Subject: RE: Few other points RE: FW: Taco Bell at 1363 Washington Avenue, Portland, ME

TACO BELL
1363 WASHINGTON AVE.
PORTLAND, ME

EXTERIOR ELEVATIONS

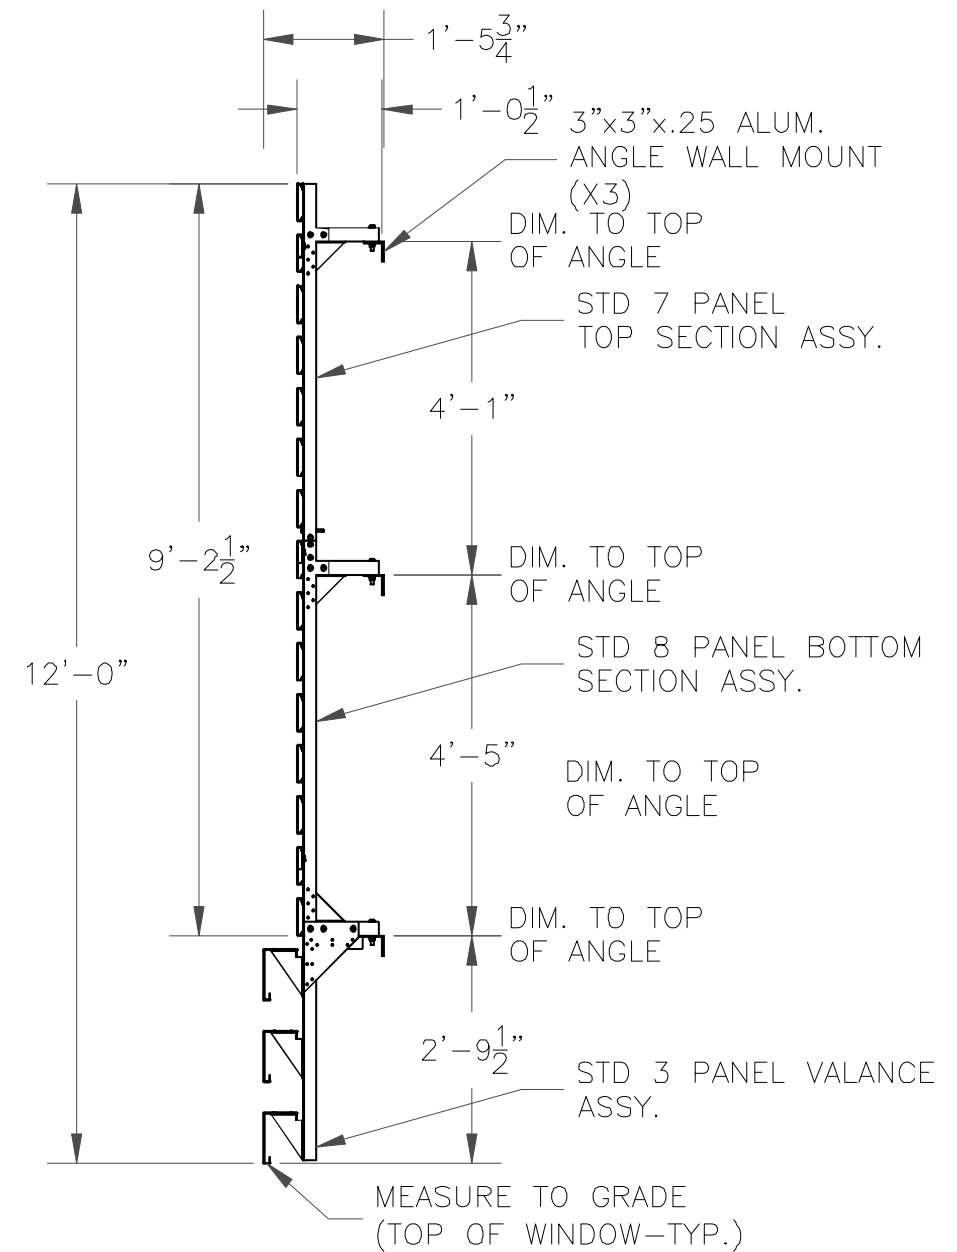
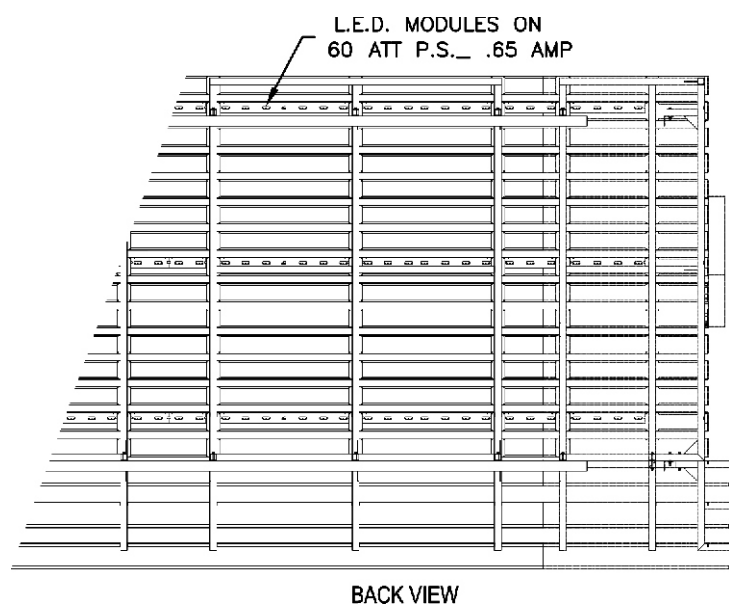
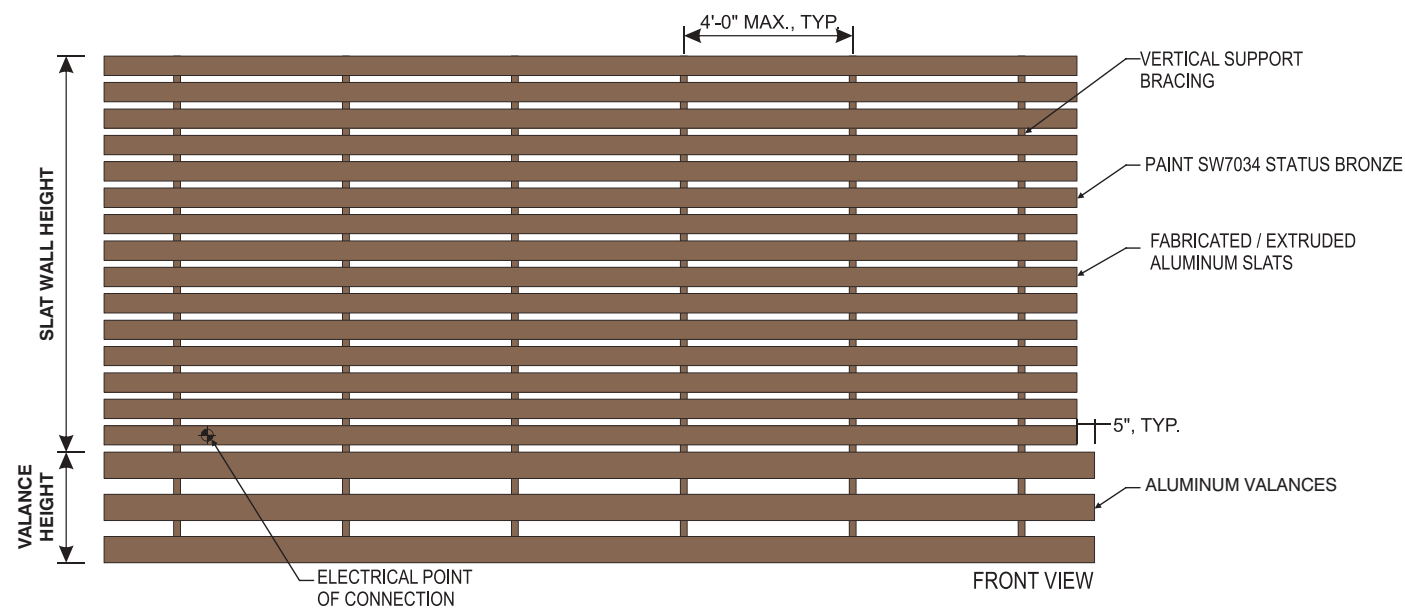
2. The material of the slat wall is aluminum per the attached detail and we have updated the rendering to state the material accordingly.
3. See attached updated site lighting plan/photometric which includes building light sconces noted (fixture TB on the attached photometric plan). Pertaining to the parking lot lights (fixture A on the attached photometric plan), the site lighting vendor has changed the fixtures from 396W fixtures to 52W fixtures and reduced the pole height from 25' to 17'-6" along with changing the location of some poles. This brings the light levels below the 5 fc maximum allowed. Average noted on the photometric plan is 1.25 (1.25 average intended per code). The max illumination at a property line per code is stated at 0.1 FC except where abutting industrial or other non-sensitive area. As the adjacent sites are similar in nature (no parks, residents, etc) the photometric plan should meet the intent of the code.

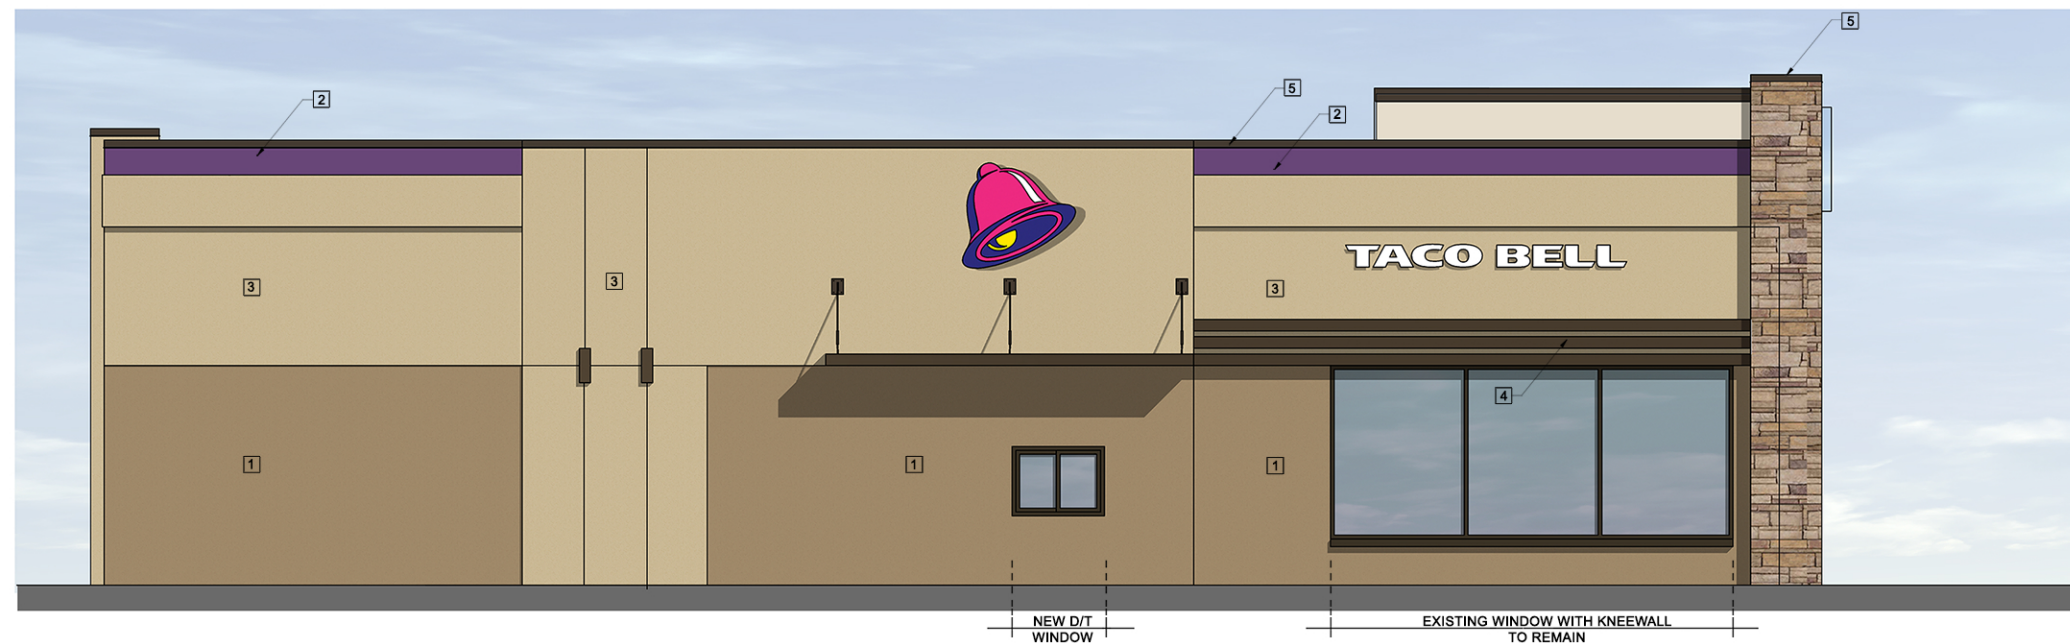
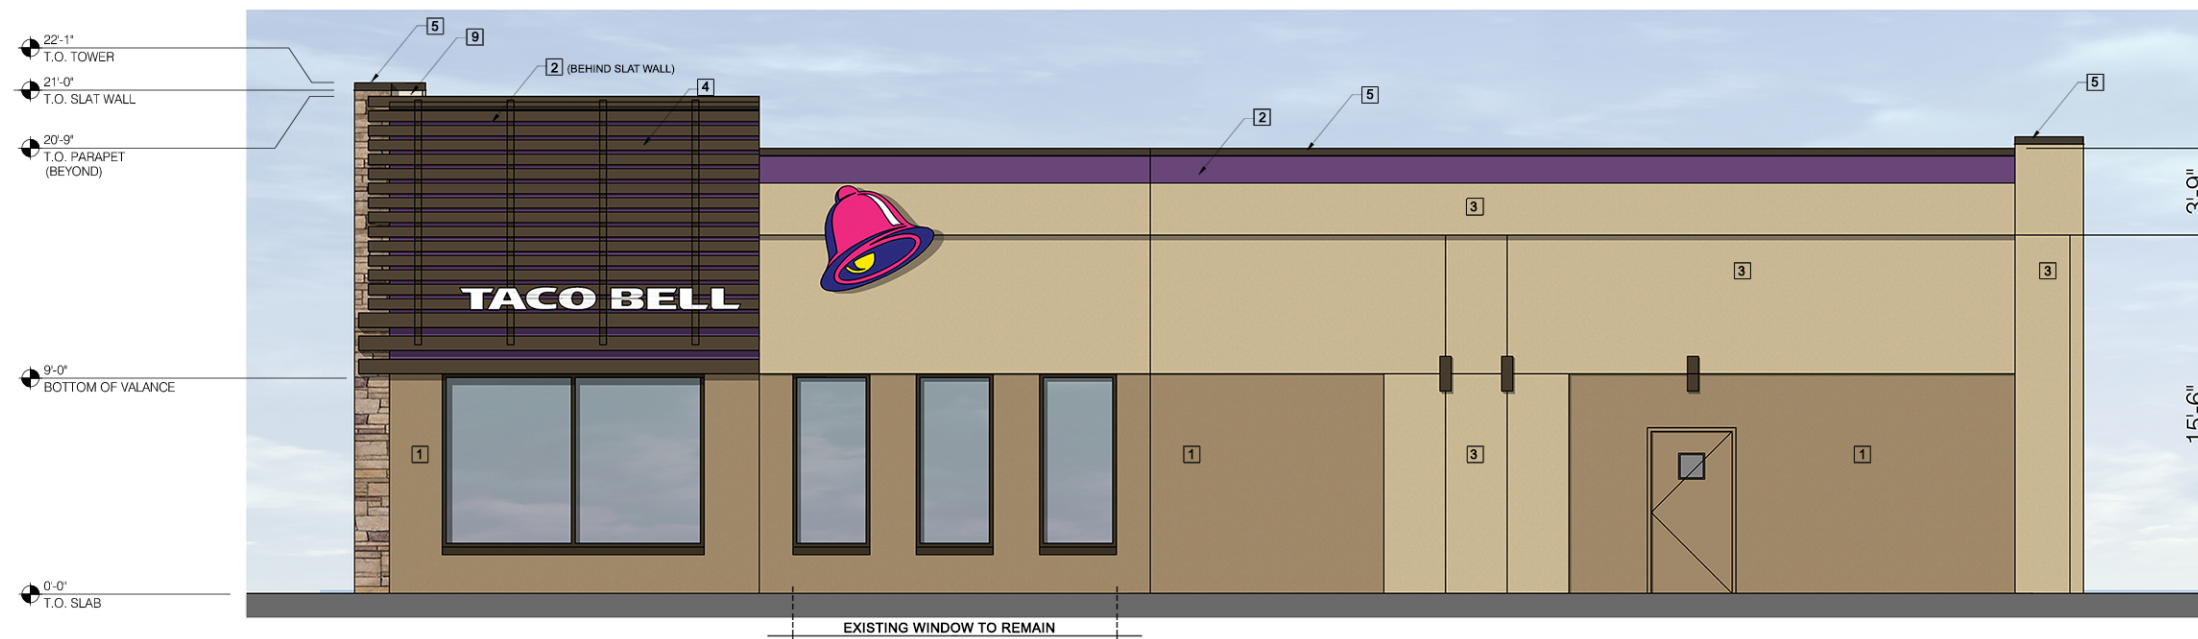
1. Glass transparency. We are reusing the existing windows with existing brick kneewall, where we can and will be providing new where existing windows showed signs of being damaged or not tempered. Where new windows are required we will be using the typical window spec for Taco Bell is Solarban 60 Starphire Ultra-Clear Glass, and then match existing tint so there is consistency in the appearance of the windows.

NOTE: EXISTING WINDOWS NOTED TO REMAIN.
NEW GLASS TO BE SOLARBAN 60 STARPHIRE
ULTRA-CLEAR GLASS, TINT TO MATCH EXISTING
